Piper Aircraft Corporation  
Vero Beach, Florida, U.S.A.

# SERVICE No. 938 BULLETIN

Date JUNE 12, 1990

SUBJECT: Wire Protection

SKETCH "A"

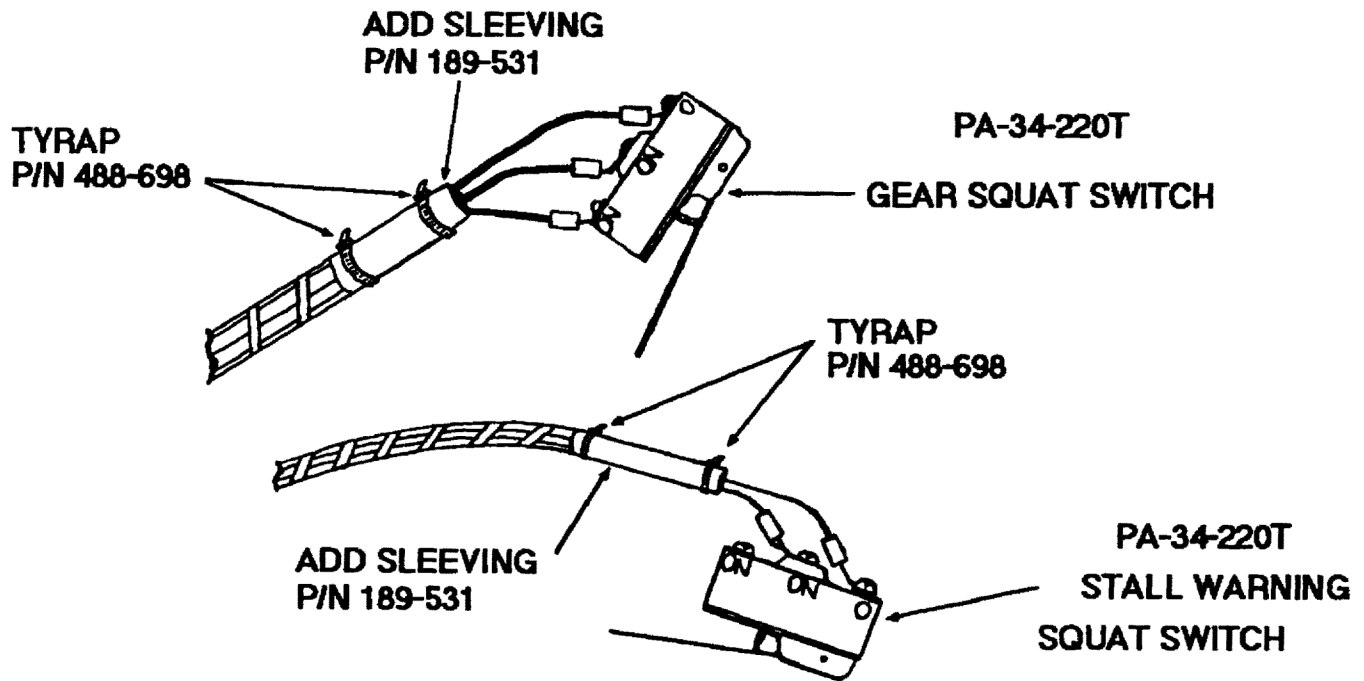
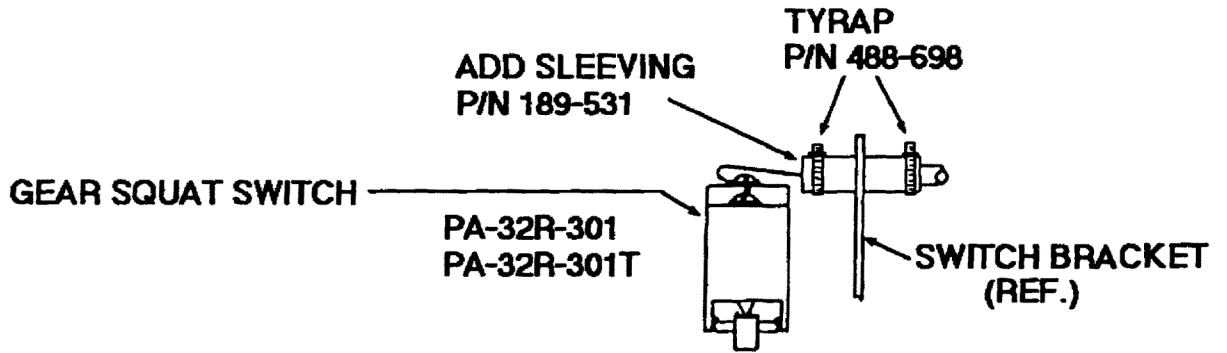
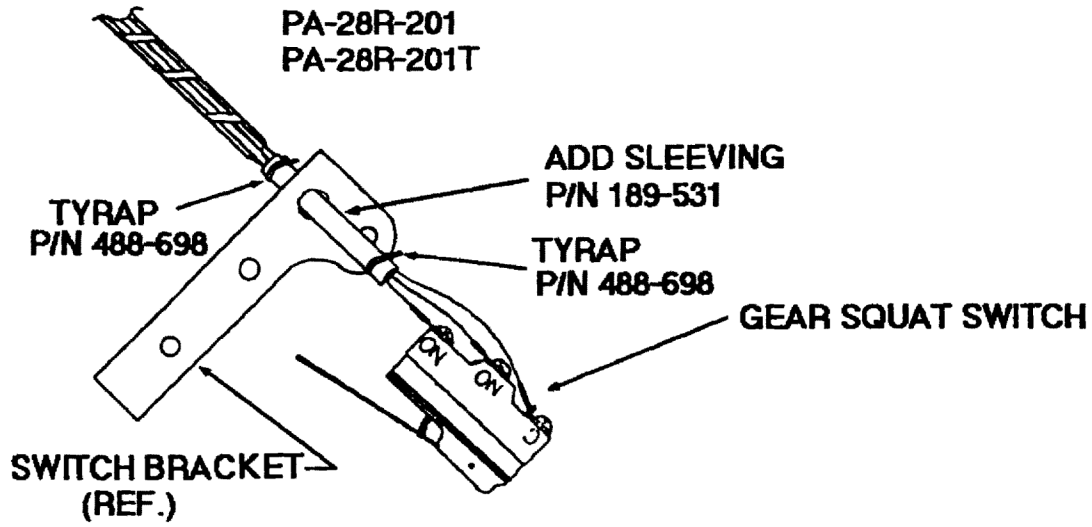
PURPOSE: Piper Aircraft has learned of a possible chafing condition affecting the wire harness to the left main landing gear squat switch and stall warning micro switch. If left uncorrected, this condition could result in failure of the two systems.

5. With wires from switch removed, install protective sleeving over wires using Tyrap, Piper Part Number 488-698, to secure sleeving in place as shown in Sketch "A" attached.

NOTE: When sleeving is secured, care should be exercised not to add any undue stress to wire/terminal when attaching to switch.
